Attachment I – Milldale North Consultation Record

Planner-led Pre-Application Meeting Record

Memorandum

Subject: Milldale North and West Fast Track Pre-referral Information

Figure 1: Wainui Road west of the development.

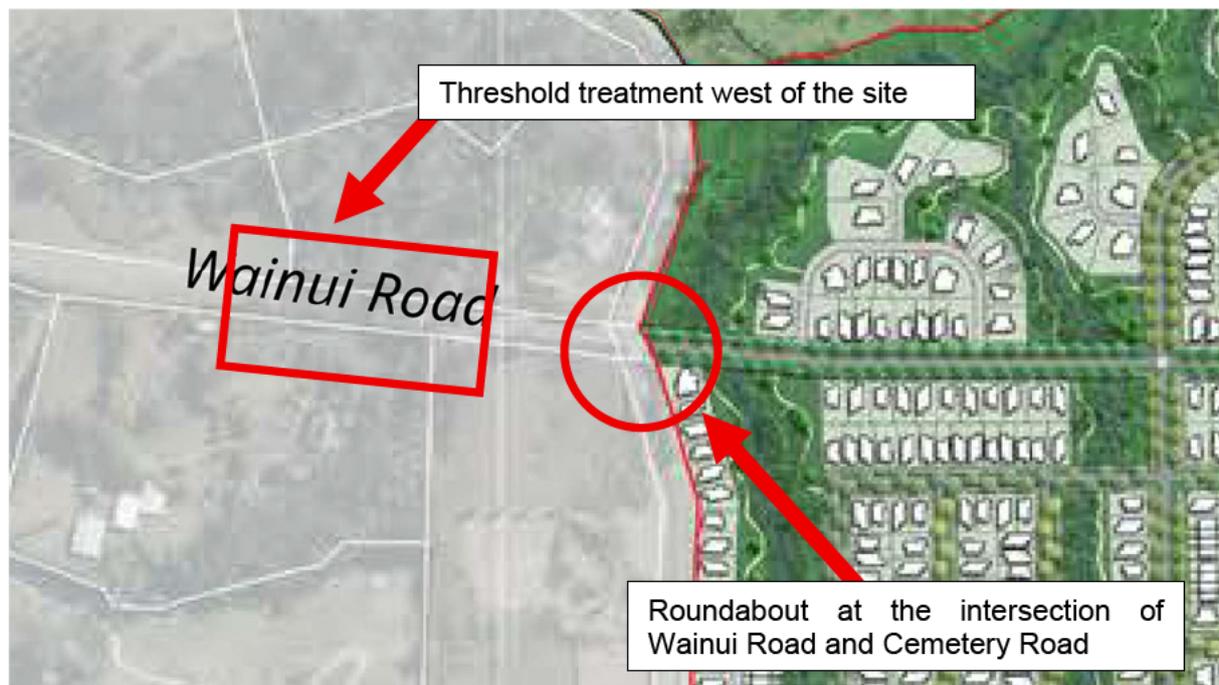
1. In order to slow drivers entering the site from the west via Wainui Rd a threshold treatment (signs, markings, kerbs, potentially landscaping) is needed on Wainui Rd to the west of Cemetery Rd to warn drivers that they are approaching an urban area and a roundabout will be needed at the Wainui Rd to the west of Cemetery intersection to physically slow traffic at the edge of the site. Refer Figure 1.

Figure 4: Example of a Y-shaped intersection.

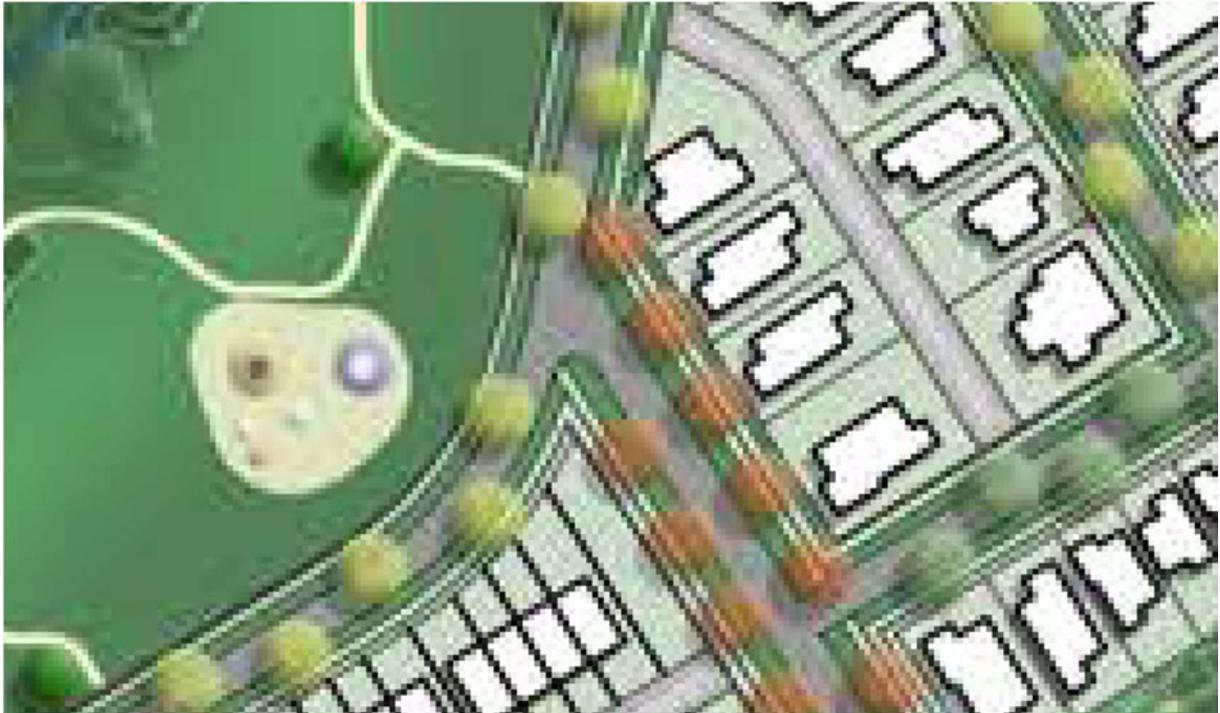
12. The masterplan is showing a number of intersections where the roads intersect at an angle which is not 90 degrees (plus or minus 10 degrees). This typically results in a wider intersection for truck tracking, longer crossing distance, higher vehicle speeds for some movements, a poor viewing angles for drivers.
13. Where intersections at angles other than right angles cannot be avoided a roundabout is the preferred type of intersection.
14. Some examples of this are shown in the figures below.

Figure 7: Example of driver sight distance from intersection limited by curve.

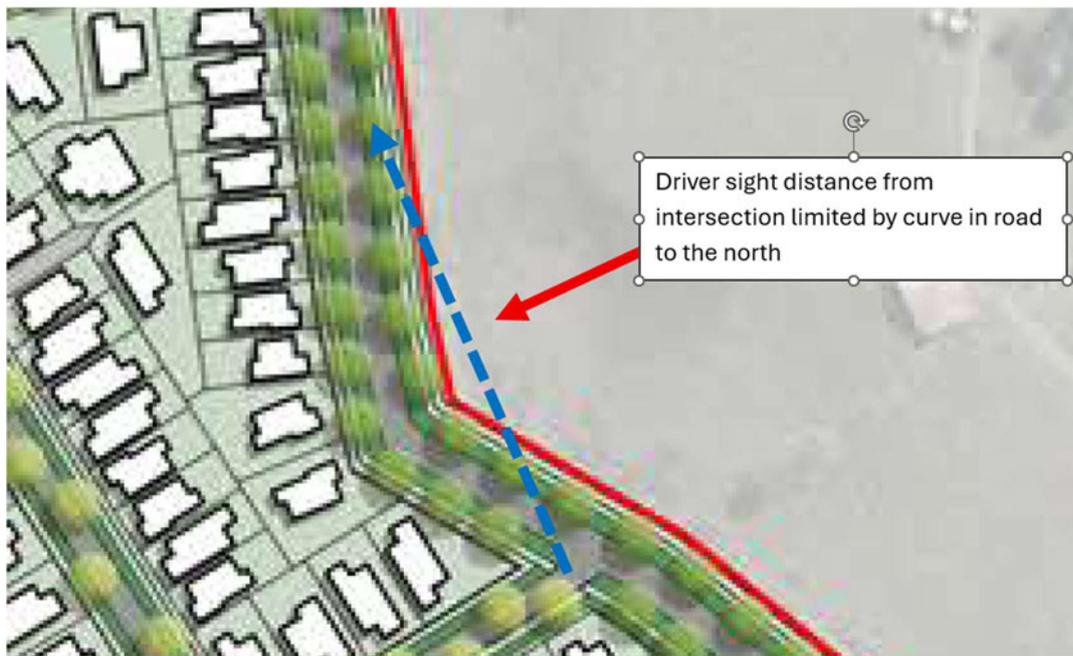
15. Intersections should be positioned away from curves in order to ensure that engineering standards (specifically Austroads Guide to Road Design Part 4A Safe Intersection Sight Distance) requirements can be met.
16. I have shown some examples of potentially problematic intersections from the master plan below.
